PRELIMINARY REVIEW SUMMARY REPORT FOR CLAIM NUMBER 15588; SITE ADDRESS: 1998 TICE VALLEY RD, WALNUT CREEK

REVIEW SUMMARY REPORT – ADDITIONAL WORK PRELIMINARY REVIEW – DECEMBER 2013

USTCF Claim No.: 15588	GeoTracker Global ID: T0601300733
Site Name: Chevron	Site Address: 1998 Tice Valley Boulevard Walnut Creek, CA 94598
Responsible Party: Chevron Products Company Attn: Joe Watterson	Address: 6101 Bollinger Canyon Road Bld BR1X #5339 San Ramon, CA 94583
USTCF Expenditures to Date: \$0	Number of Years Case Open: 15

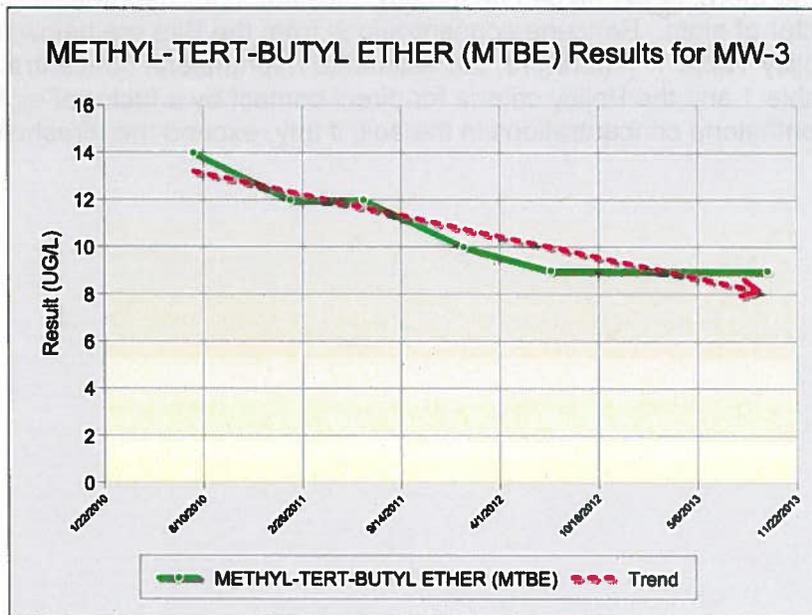
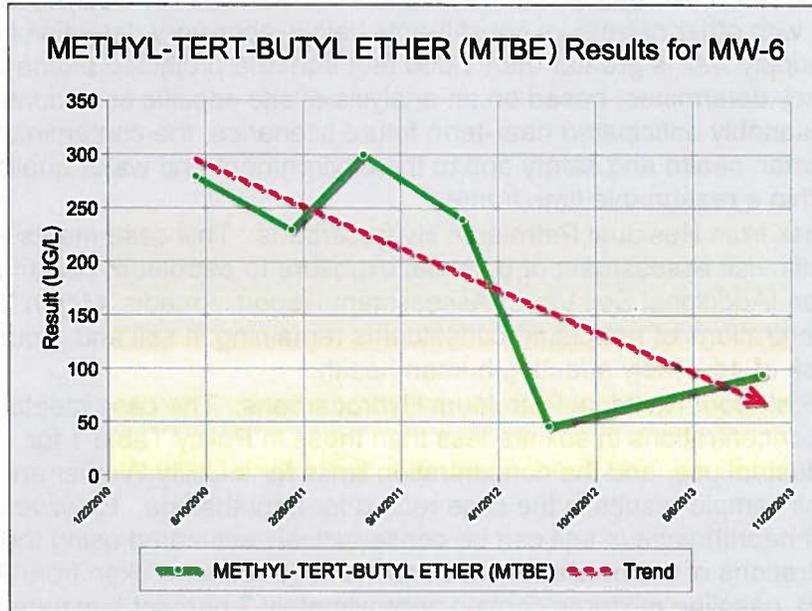
- Since 2005, six groundwater monitoring wells have been installed and irregularly monitored. MTBE trends in the downgradient wells MW-6 and MW-3 are shown below:

- Contaminated Zone(s) Used for Drinking Water: No.
- Groundwater Risk from Residual Petroleum Hydrocarbons: The case meets Policy Criterion 1 by Class 5. Although Tice Creek is located approximately 300 feet southeast from the projected MTBE plume boundary, the concentrations are low and decreasing. Monitoring well MW-3 located between the source of release and the creek has consistently shown low MTBE concentrations, with other petroleum constituents below laboratory detection limits. The nearest water supply well is greater than 1,000 feet from the projected plume boundary. The regulatory agency determines, based on an analysis of site specific conditions, which under current and reasonably anticipated near-term future scenarios, the contaminant plume poses a low threat to human health and safety and to the environment and water quality objectives will be achieved within a reasonable time frame.
